CITY OF CANADA BAY GLADESVILLE BRIDGE MARINA EXTENSION

PEER REVIEW OF VISUAL IMPACT ASSESSMENT

S20-0086 ISSUE B

Figure 4.1- Public views locations (extracted from VIA report prepared by ARPL)

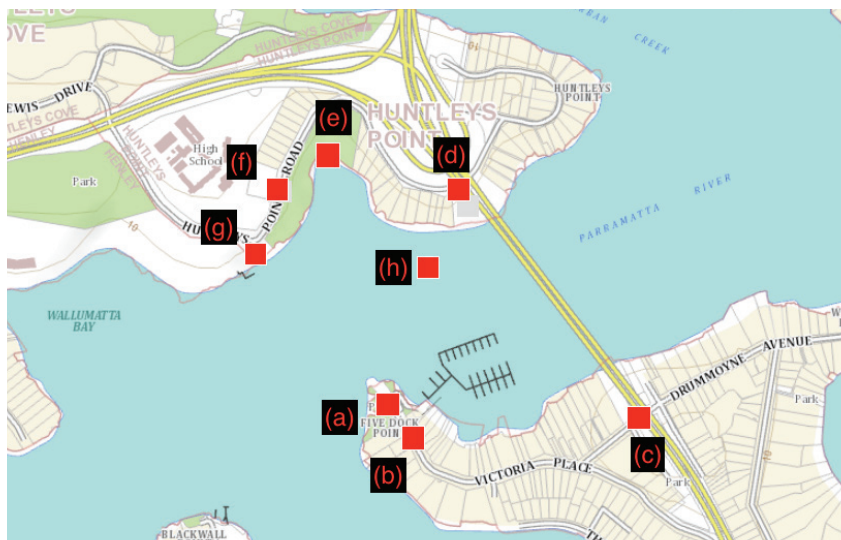
In general the eight views selected for the public realm (see Fig 4.1) seem reasonable, with one notable exception, being the omission of any views from the Huntley's Point ferry wharf and access paths, highlighted here for reasons outlined below.

It is arguable that in terms of user activity an additional view could have been selected from the ramps or the pontoon of the ferry wharf at Huntleys Point, from which the proposal will be visible by significantly larger numbers of users than from the adjoining lookout.

Finally, in passing, it is not clear why the views listed on the map in Image 3 of Section 3.0 are listed alphabetically, whilst the same views are listed numerically in Section 4.
